## DEVELOPMENT APPLICATION ASSESSMENT REPORT

<b>Application Number:</b>	DA2024/0563
----------------------------	-------------

<b>Responsible Officer:</b>	Reeve Cocks
<b>Land to be developed (Address):</b>	Lot 2583 DP 752038, 6 Lewis Street BALGOWLAH HEIGHTS NSW 2093 Lot 1 DP 18143, 6 Lewis Street BALGOWLAH HEIGHTS NSW 2093
<b>Proposed Development:</b>	Alterations and additions to a dwelling house
<b>Zoning:</b>	Manly LEP2013 - Land zoned R2 Low Density Residential
<b>Development Permissible:</b>	Yes
<b>Existing Use Rights:</b>	No
<b>Consent Authority:</b>	Northern Beaches Council
<b>Land and Environment Court Action:</b>	No
<b>Owner:</b>	Eliza Susanne Smith
<b>Applicant:</b>	Performance Building Consultants

#### **Northern Elevation**

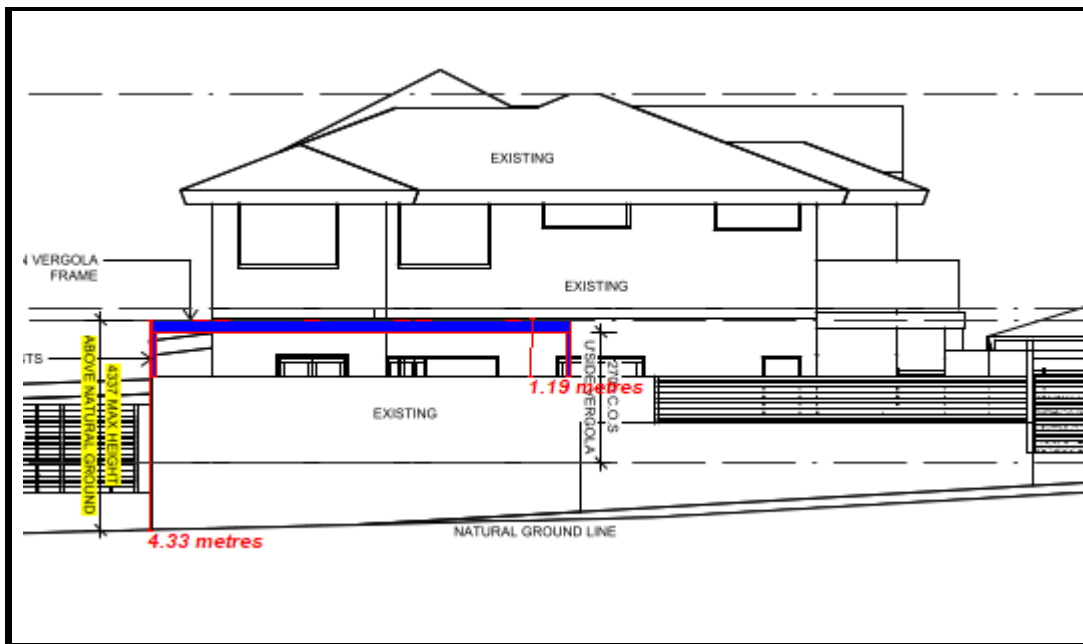
The development proposes a northern side setback non-compliance. The proposed non-compliance is consistent with the already approved non-compliant side setback of 0.27m under DA2020/0220. The development will result in a height increase of 1.2 metres along the northern side boundary. The vergola structure is open in nature and will have minimal impact on the adjoining School. It is considered that a variation of the control is reasonable in this circumstance subject to a merit assessment (see below).

The development will have no impact on the existing streetscape character due to its location on the northeastern side of the property lot. It is considered that the objective is satisfied.

The development improves privacy for the subject site, has no impact on view sharing, equitable access to light, streetscape character, and traffic conditions. It is considered that the objective is satisfied.

The development does not unreasonably limit the flexibility in the siting of buildings on site.

The development does not impact existing natural features on the subject site, adjoining sites, or the public domain.

Having regard to the above assessment, it is concluded that the proposed development is consistent with the relevant objectives of MDCP and the objectives specified in section 1.3(a) of the Environmental Planning and Assessment Act, 1979. Accordingly, this assessment finds that the proposal is supported, in this particular circumstance.
